Subject: San Joaquin Solar 1 LLC and San Joaquin Solar 2 LLC
Fresno County, California 08-AFC-12

San Joaquin Solar 1 & 2 Hybrid Project

2nd Response to CEC Data Request

Set #1, 08-AFC-12

SOURCES: Ford, Bacon, & Davis; 10/24/2008.		PRELIMINARY CUT AND FILL PLAN SAN JOAQUIN SOLAR 1 & 2	
	CREATED BY: JS	DATE: 5-29-09	FIG. NO:	
Not to Scale	PM: AR	PROJ. NO: 27658033.00200	DR-54

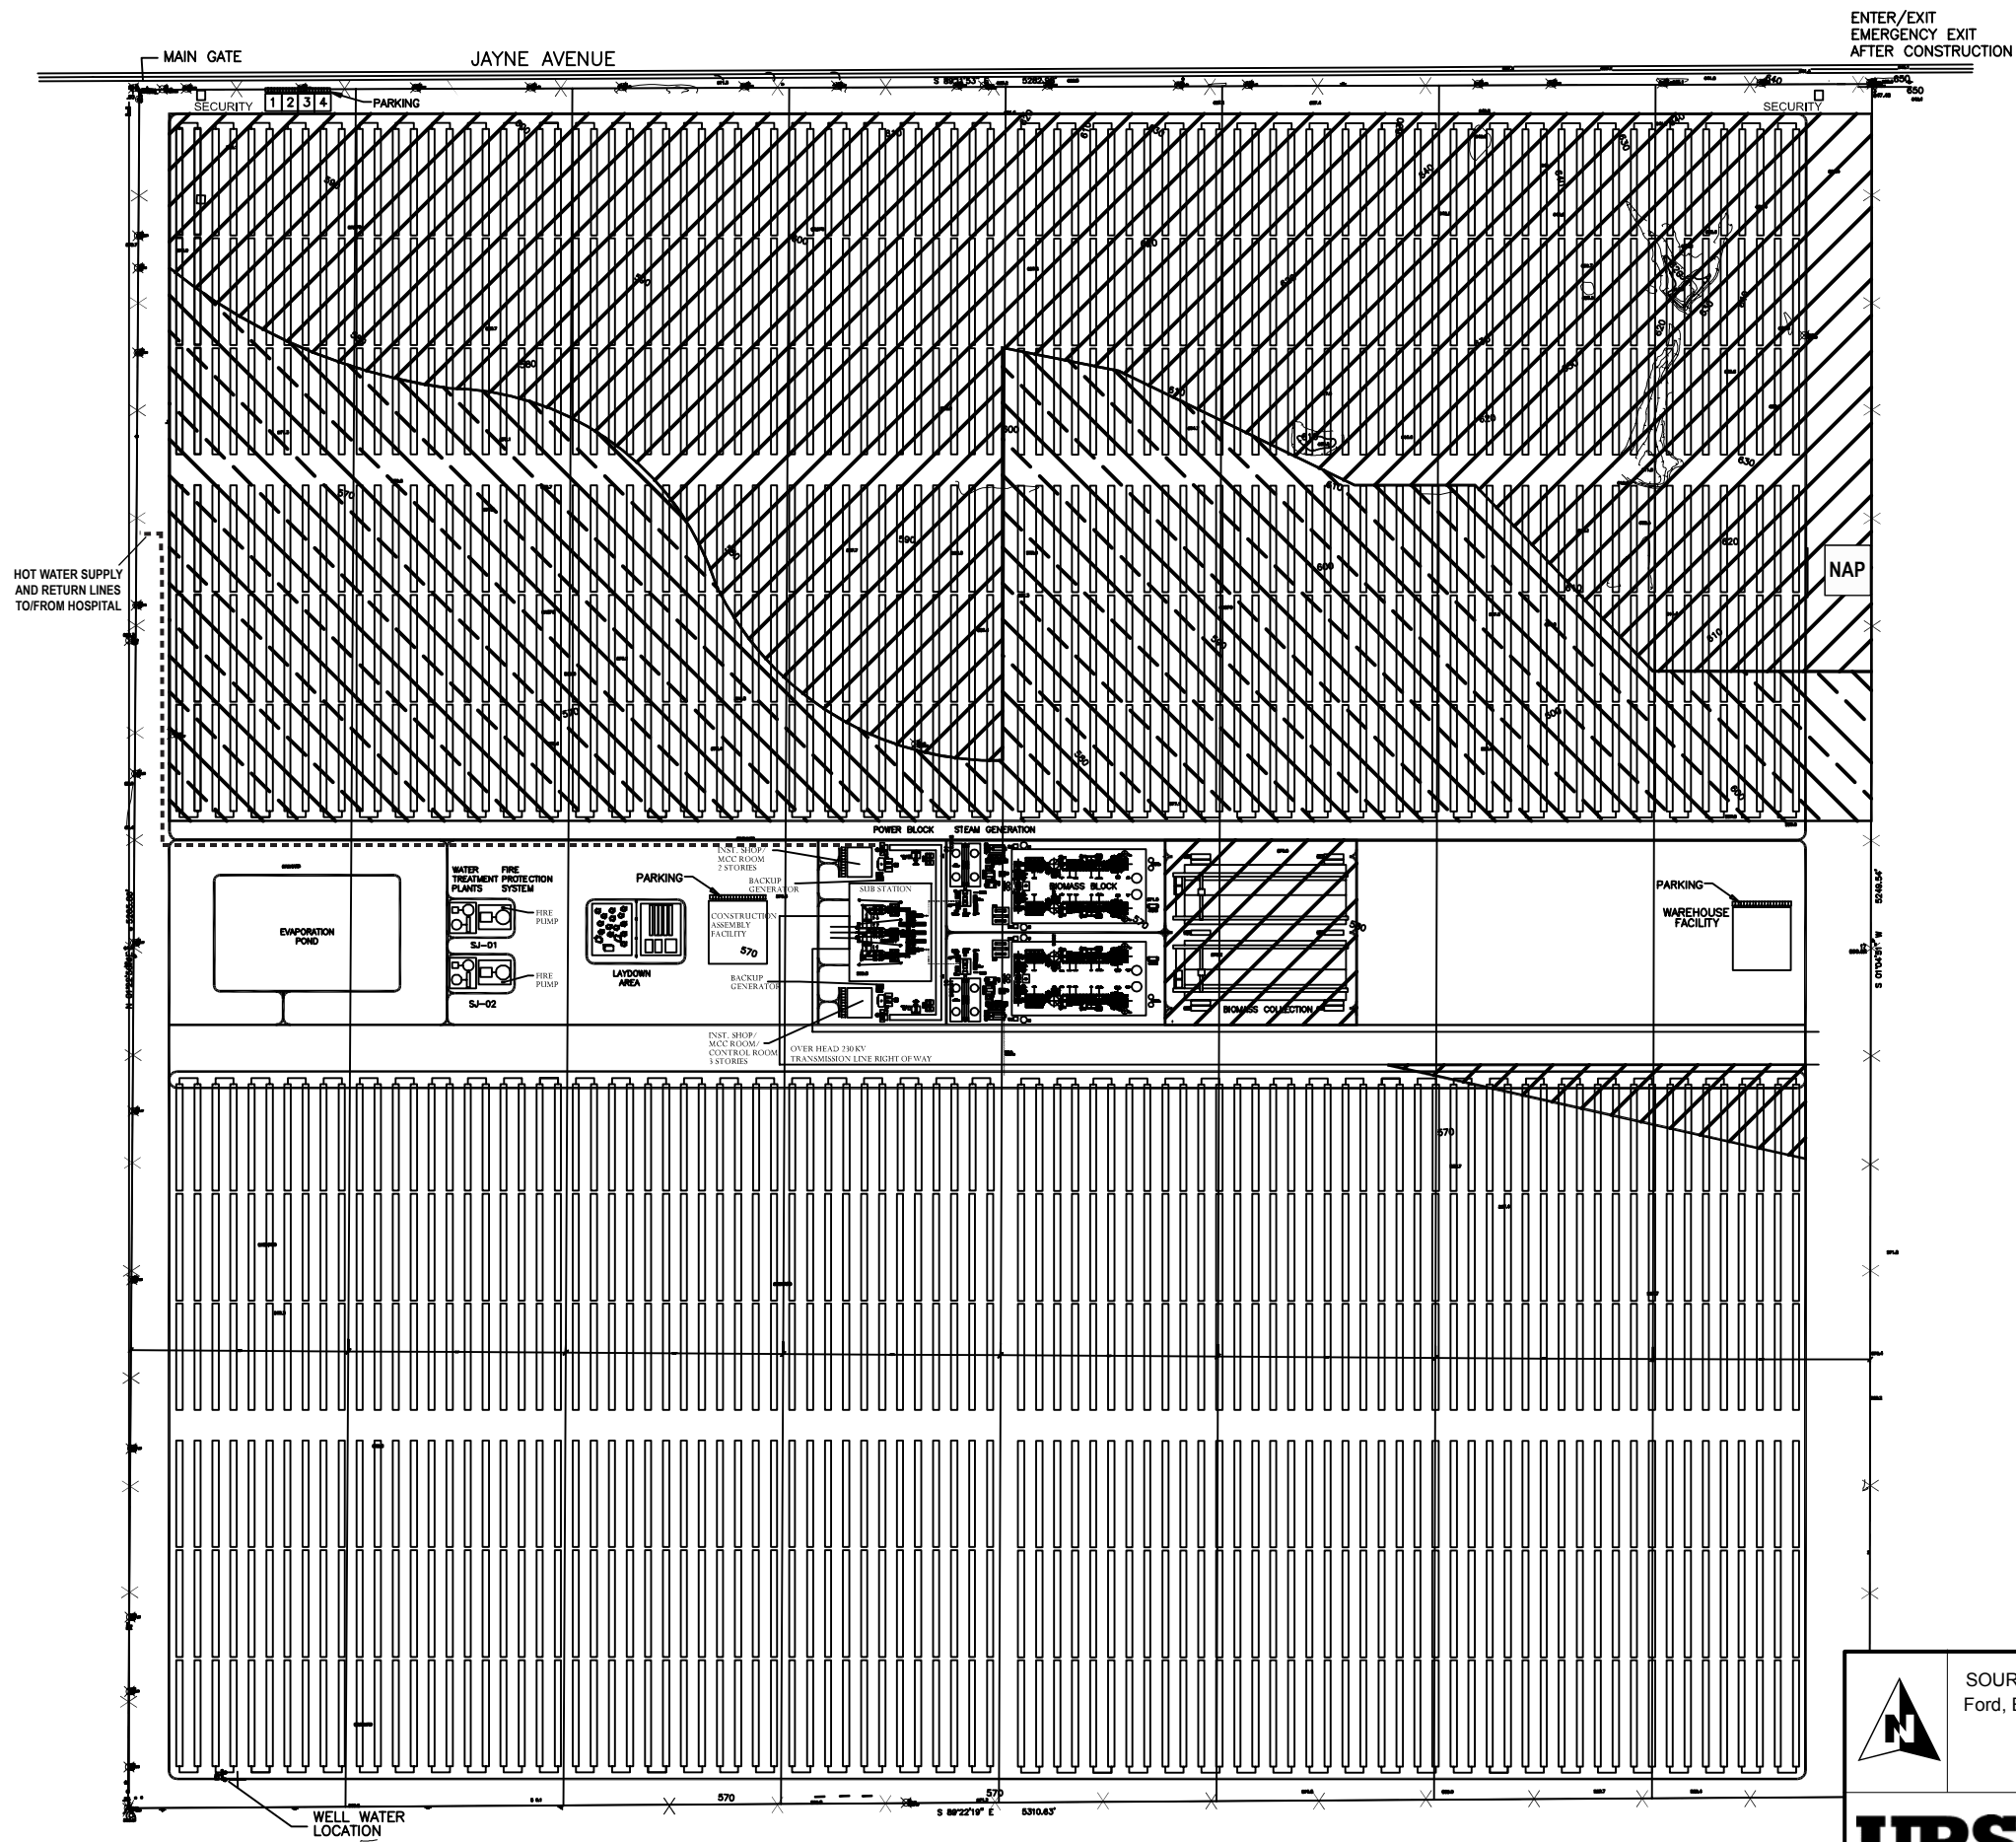
Data Request 54: Please provide a project site plan showing the locations where excavation would exceed three feet below the surface by shading or other such convention.

Response: Please see the attached Figure DR-54 (next page), which details the locations where excavation activities would exceed three feet below the surface.

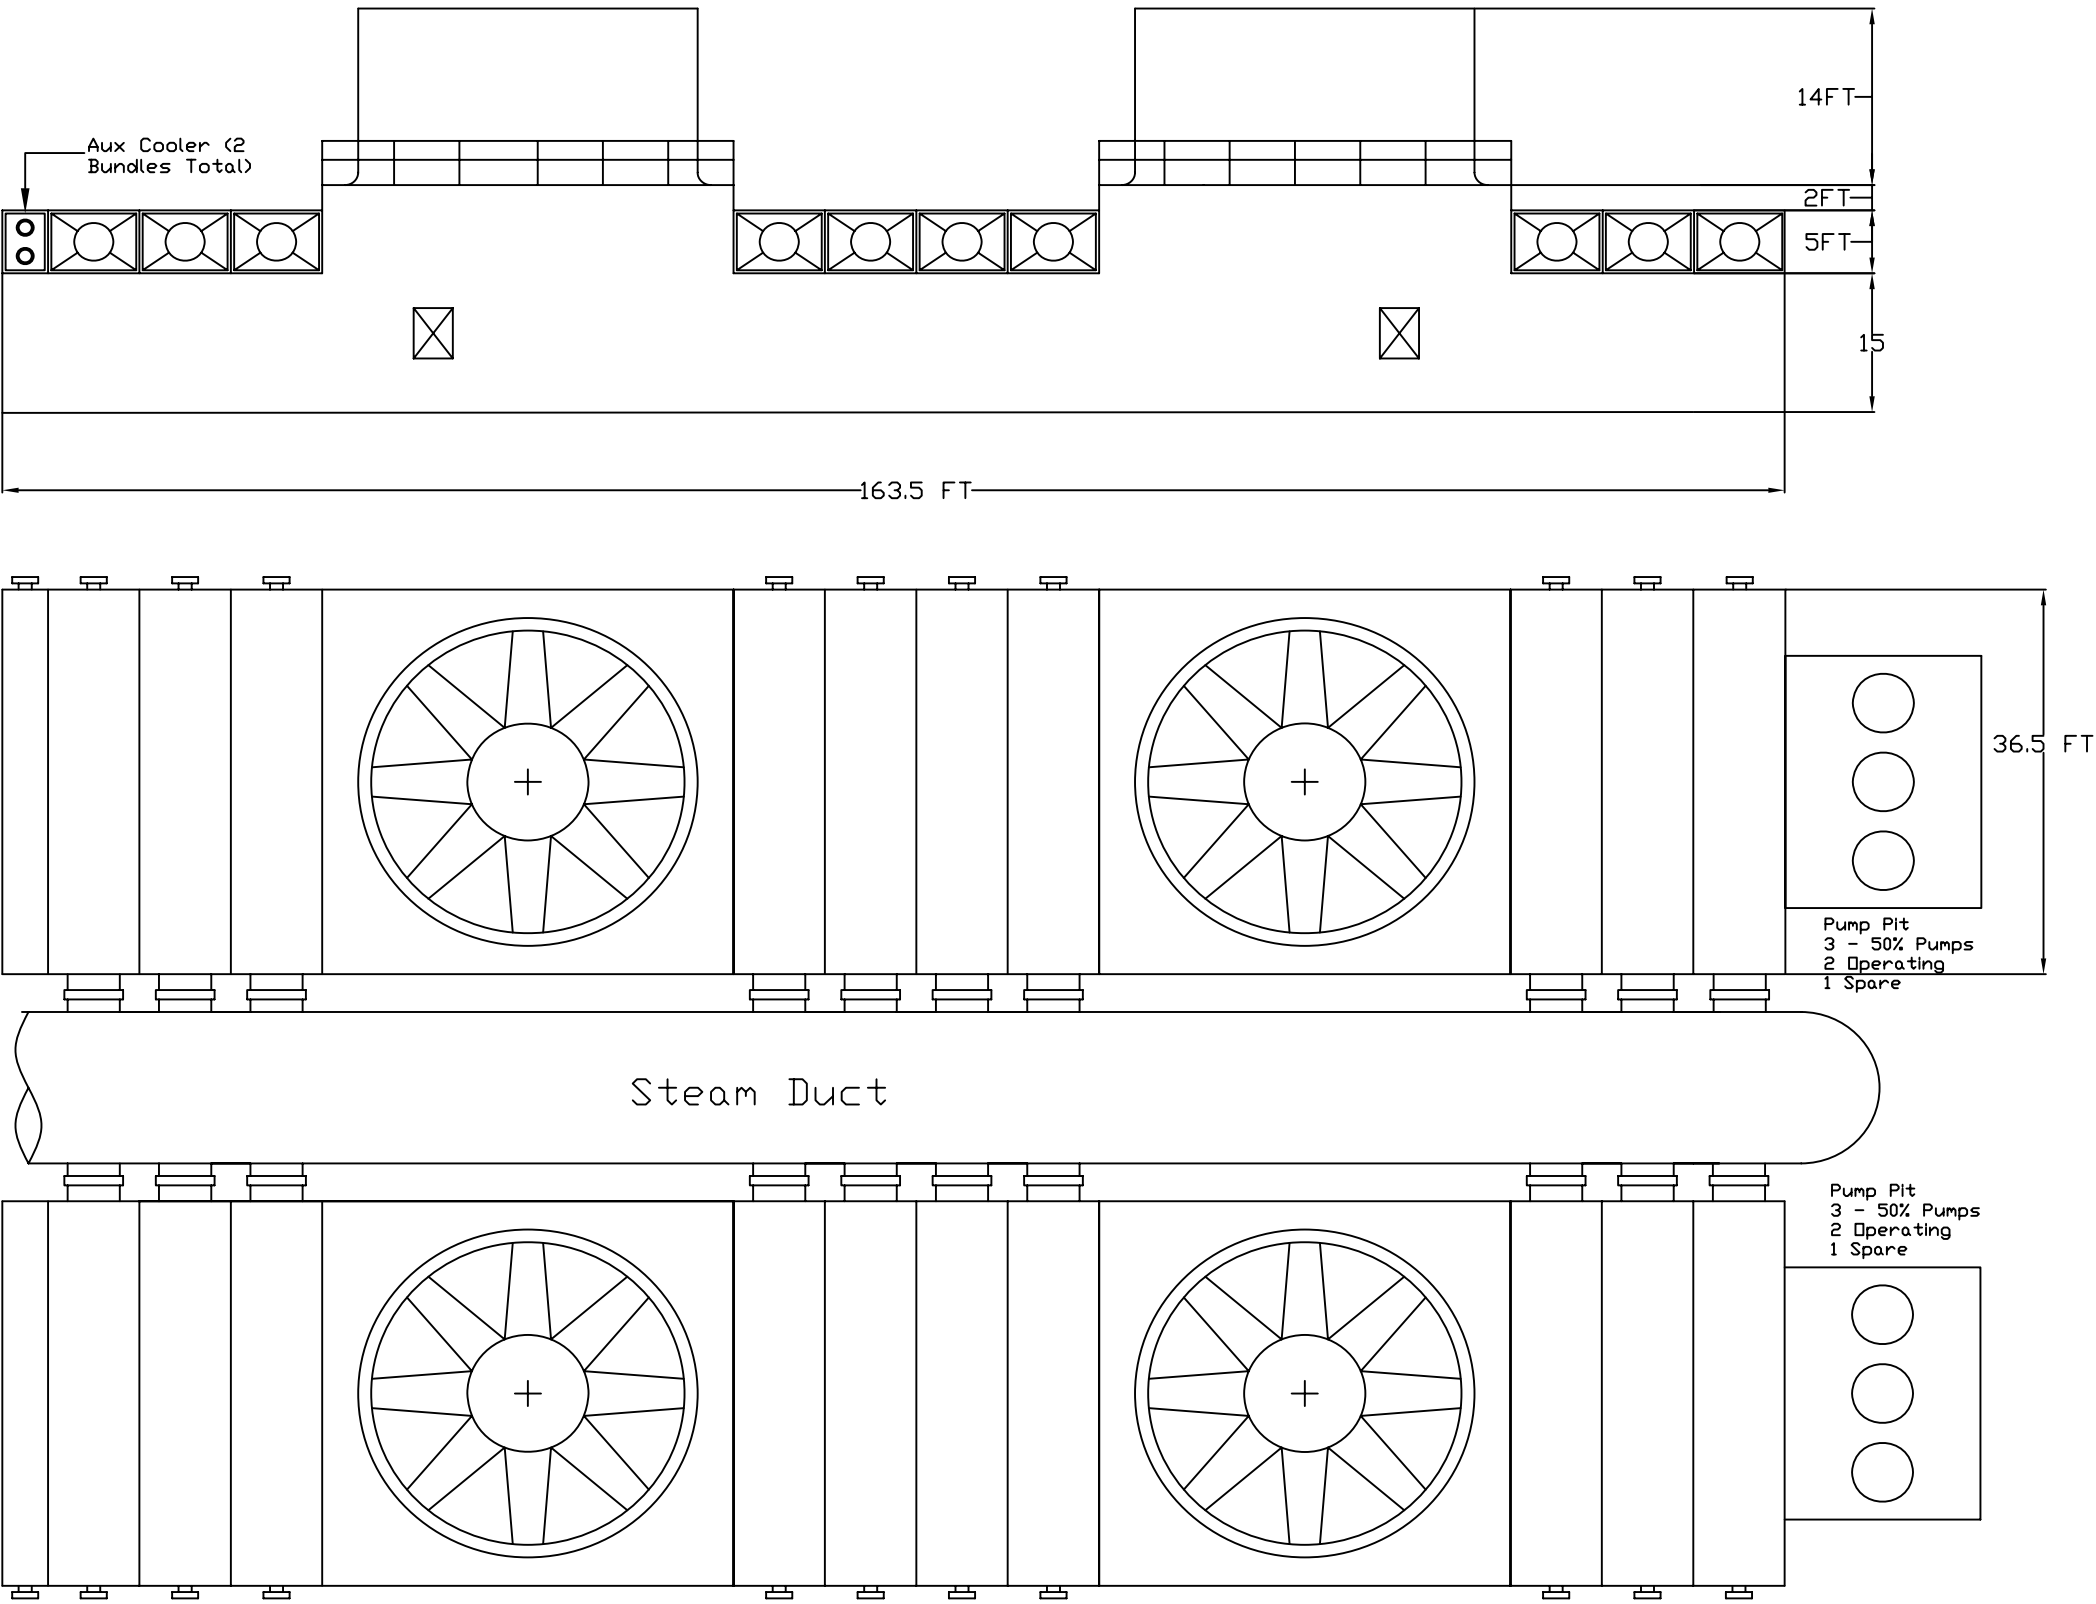
Data Request 138: Please provide the cooling tower manufacturer and model number information and a fogging frequency curve from the cooling tower vendor, if available.

Response: WSAC Unit is a 2 cell Niagara unit, model No. RVC 89833-2F26. Each steam turbine requires one 2 cell WSAC unit, each cell has two fans. A fogging frequency curve is not available.
